Project	IEEE 802.16 Broadband Wireless Access Working Group < http://ieee802.org/16 >	
Title	Correction of inconsistencies for 802.16-2004 OFDMA symbol clock frequency tolerance	
Date Submitted	2005-01-20	
Source(s)	Juergen Otterbach Joerg Schaepperle Roland Muenzner Torsten Fahldieck Alcatel SEL AG	Voice: +49-711-821-32255 Fax: +49-711-821-32453 juergen.otterbach@alcatel.de
Re:	Response to the call for comments 802.16maint-04/10 Corrigendum to IEEE 802.16-2004	
Abstract	Correction of inconsistencies for 802.16-2004 OFDMA	
Purpose	Resolving ambiguity in OFDMA PHY layer §8.4	
Notice	This document has been prepared to assist IEEE 802.16. It is offered as a basis for discussion and is not binding on the contributing individual(s) or organization(s). The material in this document is subject to change in form and content after further study. The contributor(s) reserve(s) the right to add, amend or withdraw material contained herein.

Correction of inconsistencies for 802.16-2004 OFDMA symbol clock frequency tolerance

Figure 2: Signal-to-interference ratio (SIR) as a function of the absolute tolerance of the sampling clock F_s in percent of the subcarrier spacing Δf

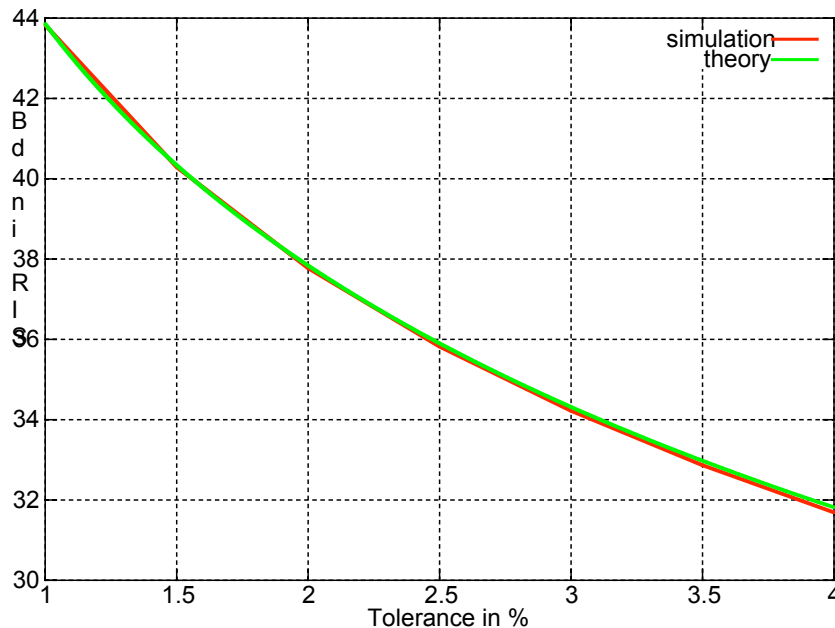
As an indication Figure 2 shows the resulting SIR values in function of the tolerance for the sampling clock frequency for a range of values, that still would leave some margin to the SNR requirement of 24.4 dB for 64 QAM.

A symbol clock frequency tolerance of 2 % of the subcarrier spacing on the other hand, as currently required in 802.16-REVd/D5, results due to the above relation between the symbol clock and the sampling clock frequency in a much higher tolerance for the sampling clock frequency. Therefore this requirement on the symbol clock frequency is not sufficient.

Even though a tolerance of the symbol clock frequency accuracy derived from the range of values for the sampling clock frequency shown in Figure 2 could be sufficient, there is a more direct means to guarantee a still higher accuracy exploiting the requirement that the symbol clock frequency and the center frequency are derived from a single reference at the BS and thus have a fixed and predefined ratio within the system.

At the SS, the transmitted center frequency ~~and the symbol clock frequency~~ shall be synchronized to the BS with a tolerance of maximum 2% of the subcarrier spacing. Additionally the symbol clock frequency at the SS shall be locked to the center frequency at the SS which guarantees a relative tolerance for the symbol clock frequency at the SS of maximum $0.02 * (\text{subcarrier spacing}) / (\text{center frequency})$.
